The Southern Indian Ocean Fisheries Agreement (SIOFA) 7th Meeting of the Parties
17-20 November 2020

CC-04-11

Intersessional consultations on the HSBI
SIOFA Inspection Flag

This document is the proposal of a SIOFA inspection flag

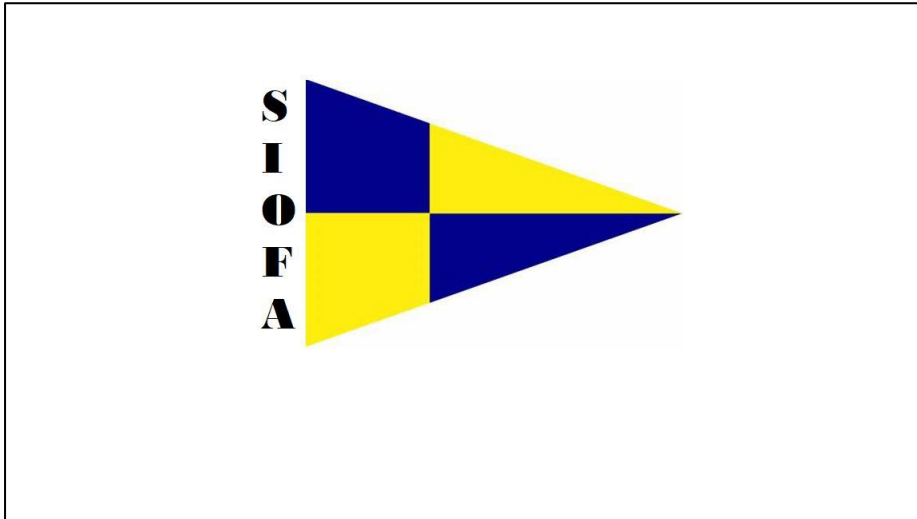
The SIOFA inspection flag circulated was the same than the one circulated by the data manager last year, only the SIOFA/APSOI mark was added on the edge. Everybody agreed with the proposed flag but contracting parties requested the inspection flag to be clearly visible and to have a proper flag size.

The Secretariat suggested the following dimension for the Boarding Pennant: 44 cm by 66 cm (height by length), which could be made of rigid material magnetized to be visibly displayed on the vessel.

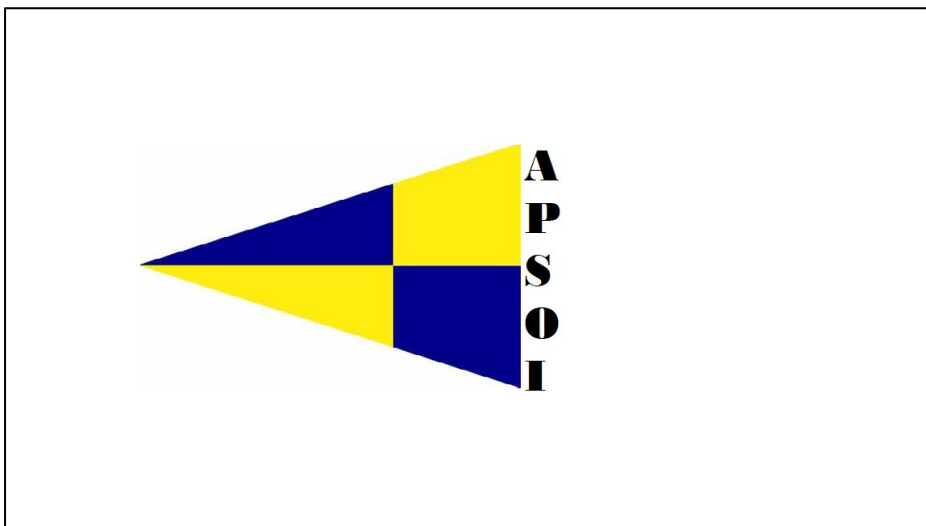
A CCP believes that the "APSOI" on the port side of the pennant may result in misunderstanding on the sea and suggests that only "SIOFA" is shown on the Boarding Pennant.

Furthermore, for this CCP in addition to the pennant, an "inspection flag" with dimensions of 94 cm by 213 cm (height by length) must also be displayed.
